# Access Compliance Report

## Public Rights-of-Way

Intersection ID: 48464	Main Street: TARPWAY_RD	Cross Street: PETE_BROWN_RD	Location: SE
ADA ID: 04DC8B7CB81E	Ramp Type: Directional1	Initial Pass/Fail: Fail	Overall Compliance: No
		Severity Score: 1.25

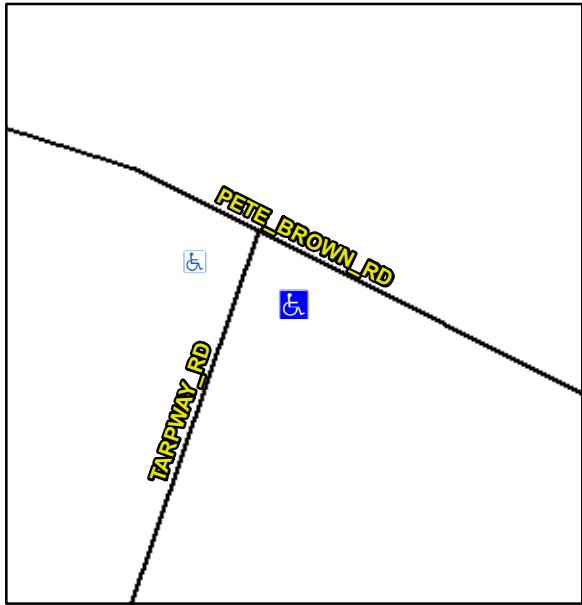
Codes/Mitigation Info/Possible Solution		Field Measurements/Component Compliance						
	Possible Solutions:							
	Remove & Replace Entire Ramp.							
	Surveyor Notes:							
	N/A							
	PROW/ADA:							
	R304.5.3							
	Street 1 Name	TARPWAY RD						
	Stop Condition-Street 1	StopSign						
	Street 2 Name	N/A						
	Stop Condition-Street 2	N/A						
Total Cost:		\$	1600.00					
		Compliance	Description	Data	Compliance	Description	Data	
		N/A	Ramp Length (in)	32.0	N/A	Grade Break?	N/A	
		Yes	Ramp Width (in)	71.0	N/A	Grade Break Slope (%)	0.0	
		Yes	Ramp Slope (%)	7.6	N/A	Grade Break XSlope (%)	0.0	
		No	Ramp XSlope (%)	3.6				
		N/A	Flare Type LT	N/A	N/A	Flare Type RT	N/A	
		N/A	Flare Slope LT (%)	N/A	N/A	Flare Slope RT (%)	0.0	
		N/A	Flare Traversable LT?	N/A	N/A	Flare Traversable RT?	N/A	
		N/A	Landing Length (in)	0.0	N/A	DWS Provided?	N/A	
		N/A	Landing Width (in)	0.0	N/A	DWS Contrast?	N/A	
		N/A	Landing Slope (%)	0.0	N/A	DWS Length (in)	N/A
